**Leicestershire County Council:
North and East Melton
Mowbray Distributor Road
(MMDR)**

Stage 1 Road Safety Audit

Job No: 60542201.M001.RSA Reference: 60542201/M001/RSA/RSA1/02 Date Created: 21st December 2018

| 60542201-ACM-ENM-S4_GEN_ZZ_Z -DR-Z -0005 | P01.3 |

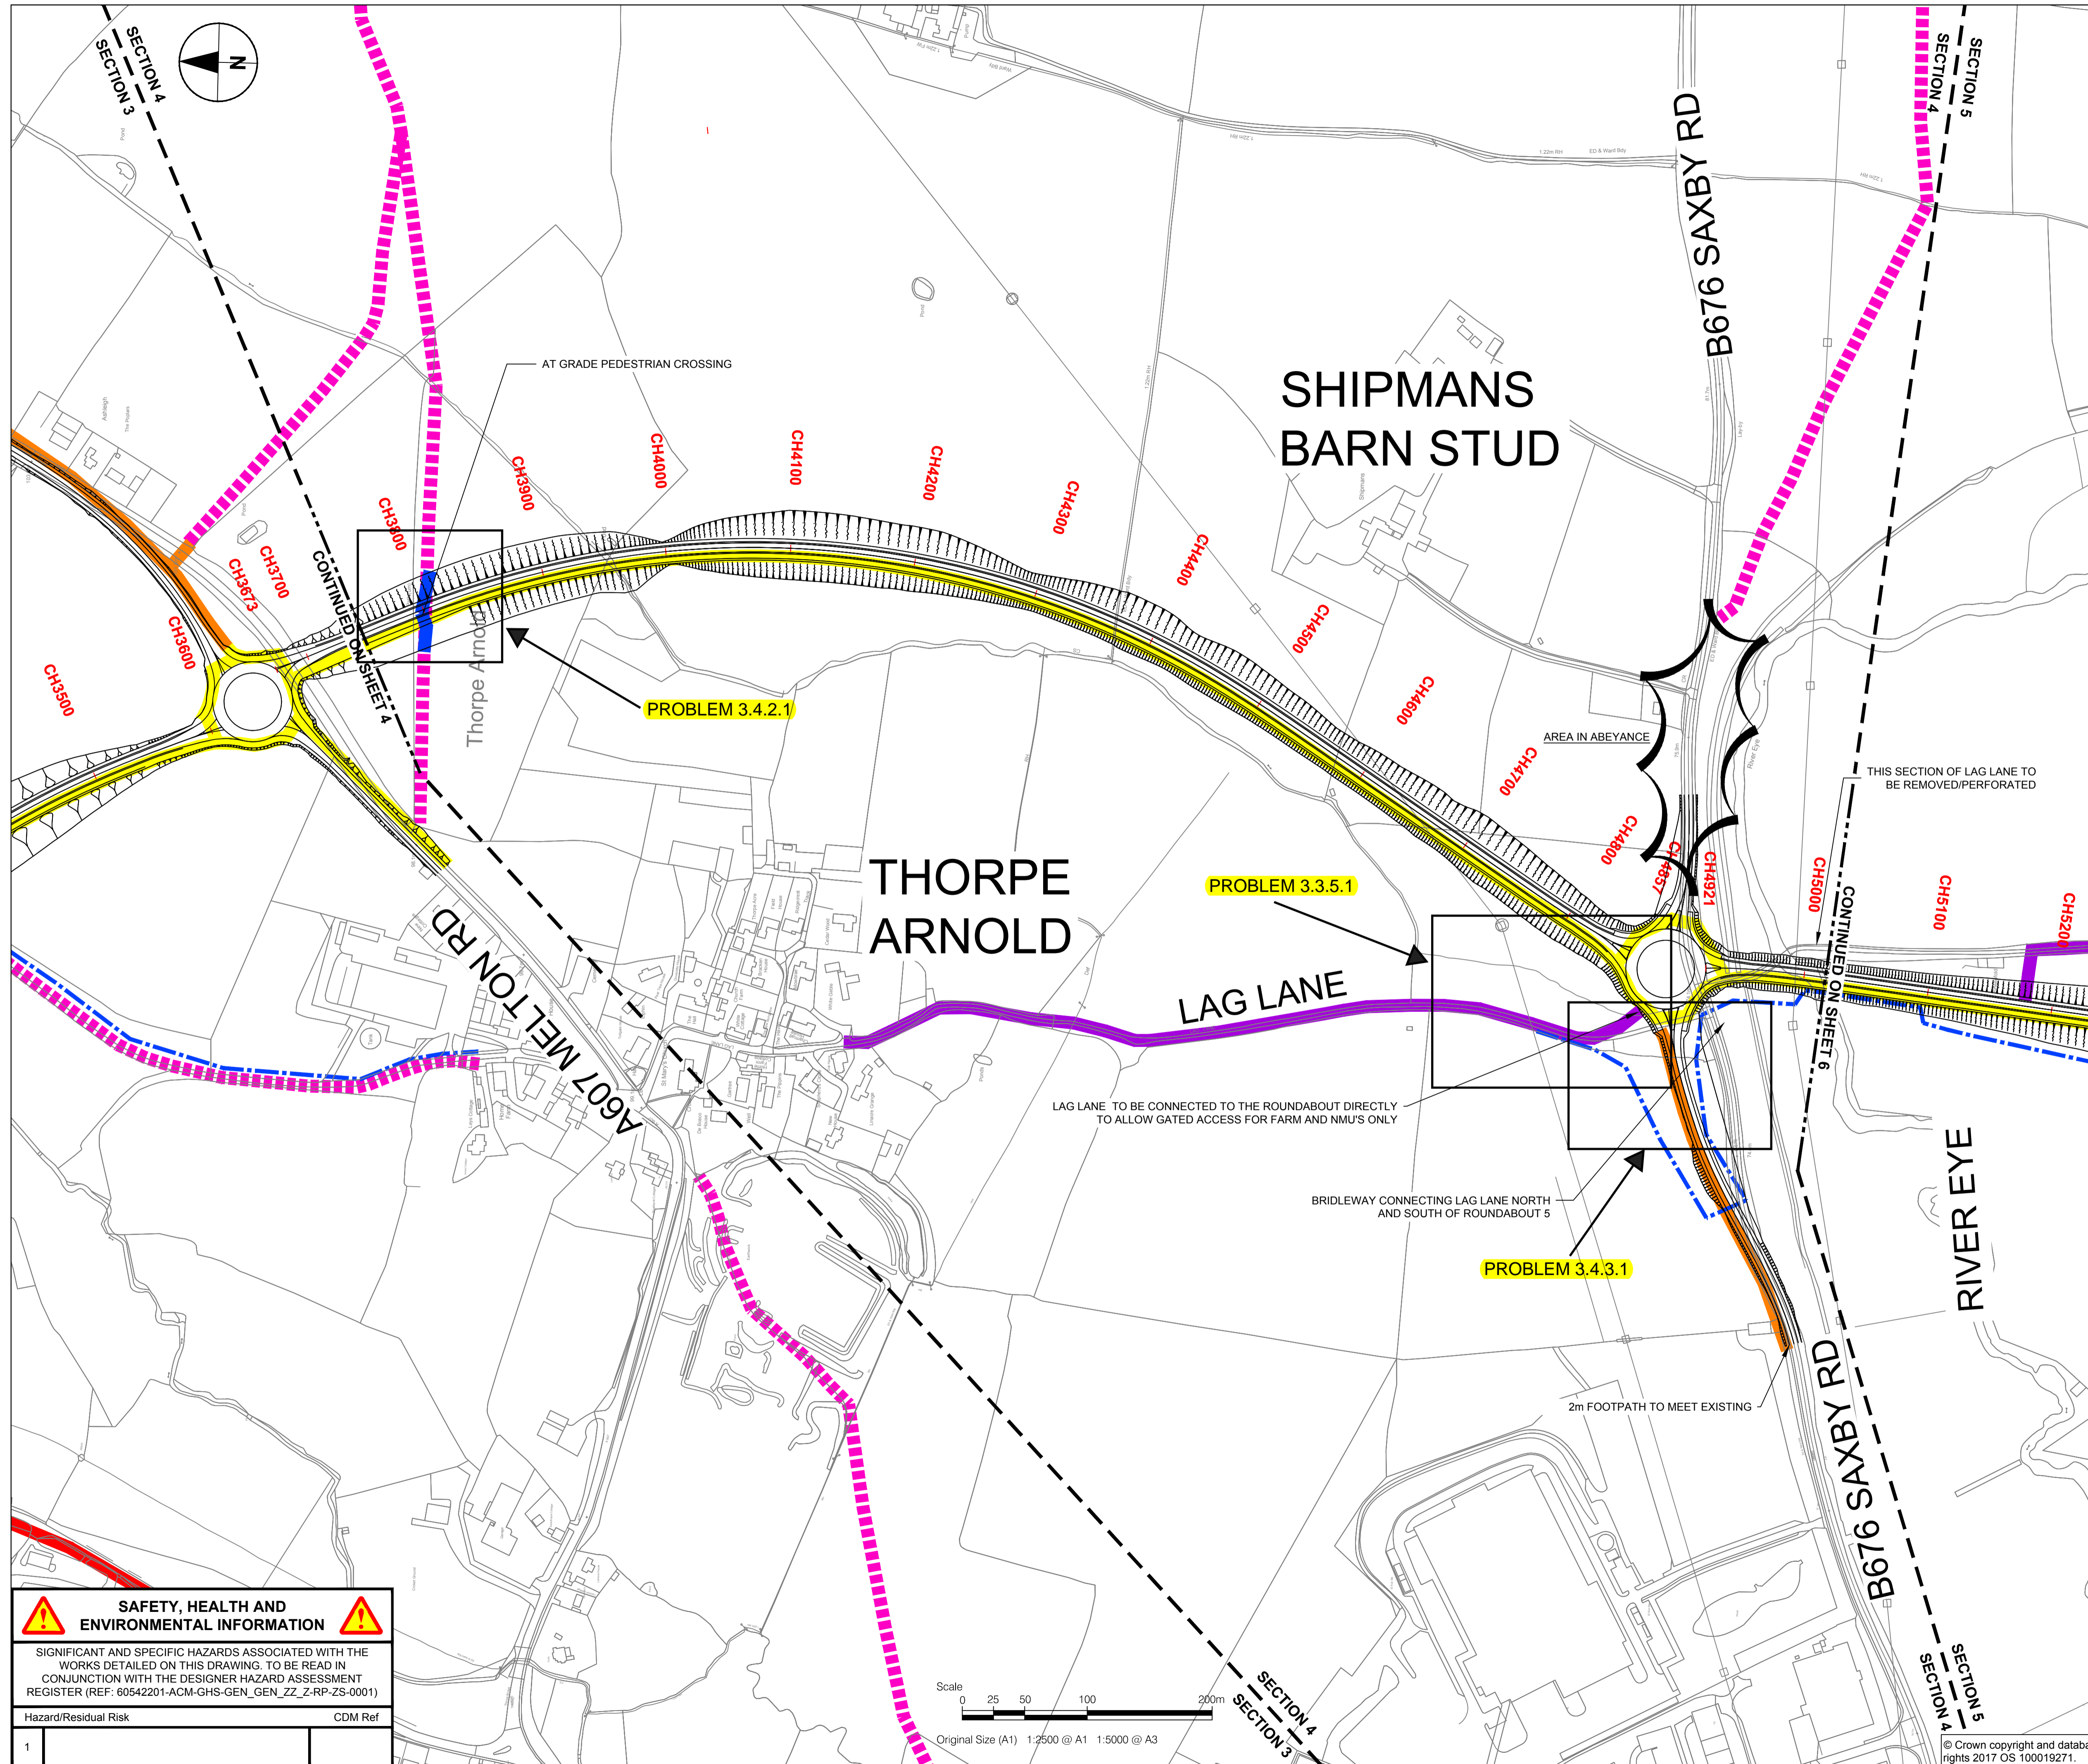
Drawing No(s): 60542201-ACM-ENM-S4_GEN_ZZ_Z-DR-Z-0005 P01.3.

Location: Lag Lane access/egress onto roundabout 5.

Summary: Inappropriate access/egress from roundabout, increasing the likelihood of collisions involving vehicles travelling around the roundabout circulatory and users entering or leaving Lag Lane.

Lag Lane is to be connected to the north-western section of roundabout 5 with a gated access provided to allow for NMU users and farm traffic to access and leave the facility. No details in relation to the gated access have been provided to the Audit Team; however there are concerns that if the gate is located too closely to the roundabout circulatory, farm traffic may stop on the circulatory increasing the likelihood of shunt type or grazing collisions occurring.

SHEET TITLE
SECTION 4 ROUNDABOUT 5
PLAN AND PROFILE

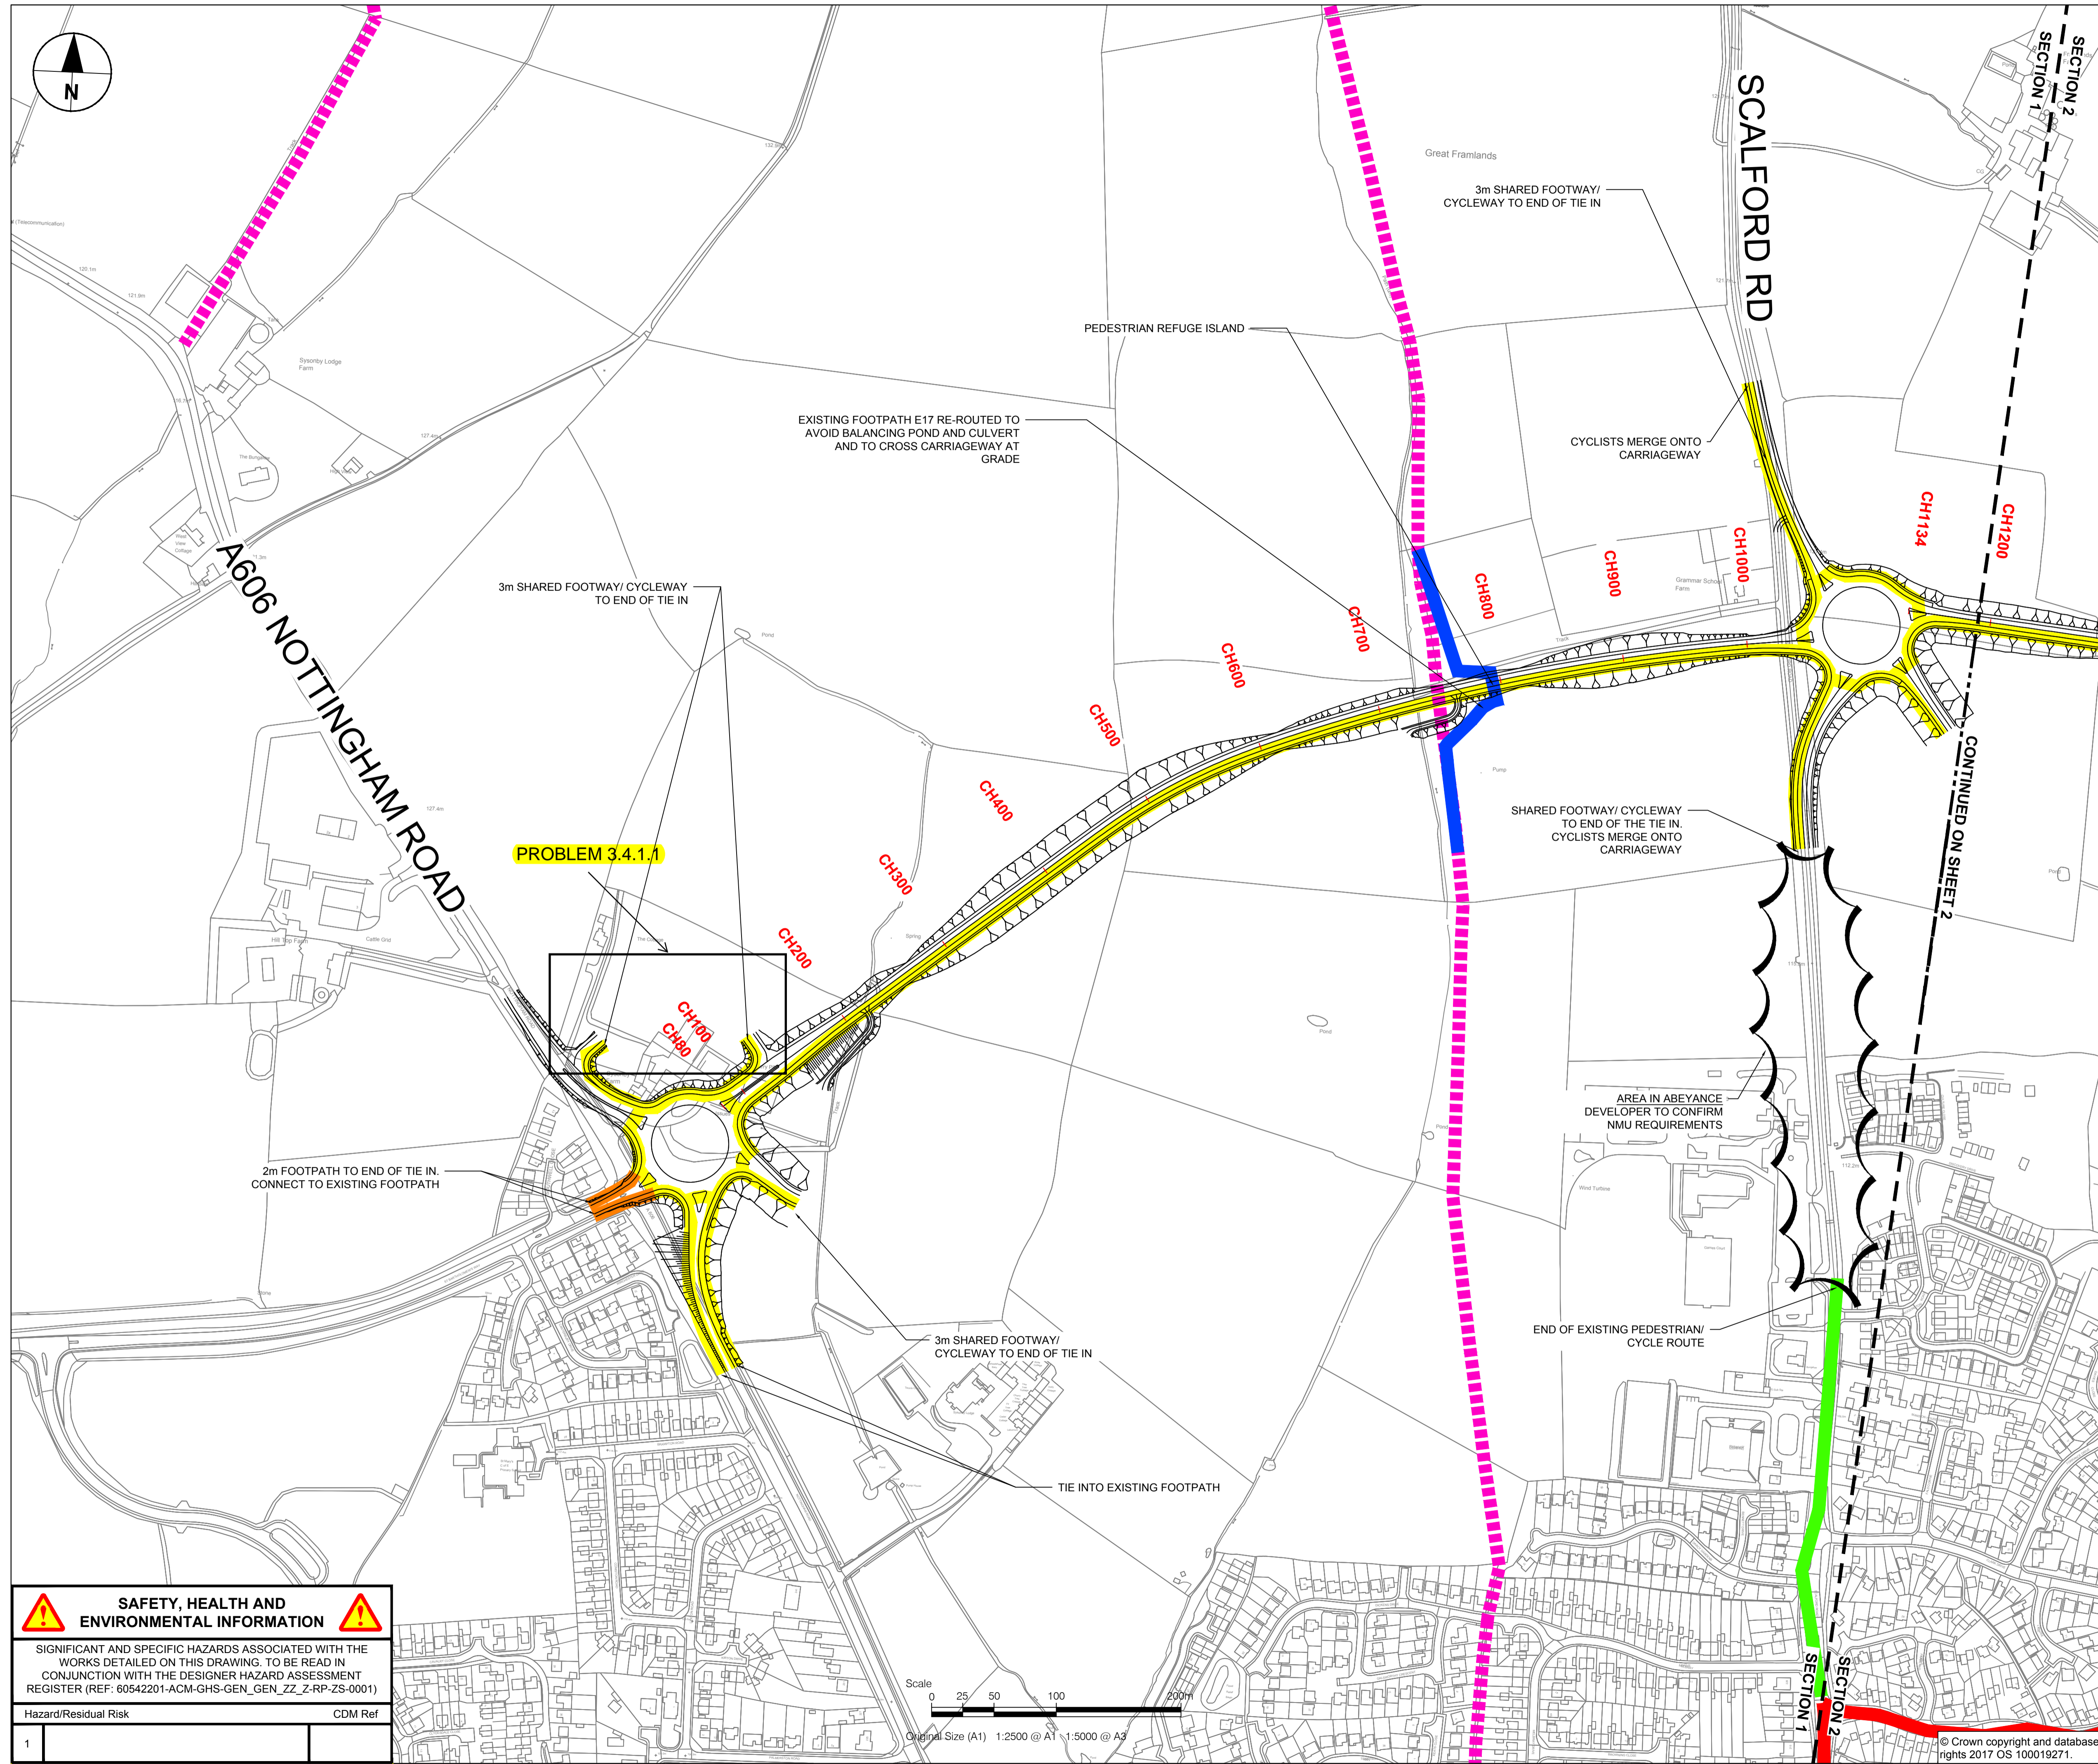
Drawing No(s): 60542201-ACM-HML-S4_JN_R05_Z-DR-CH-0001 P01.

Designer Response
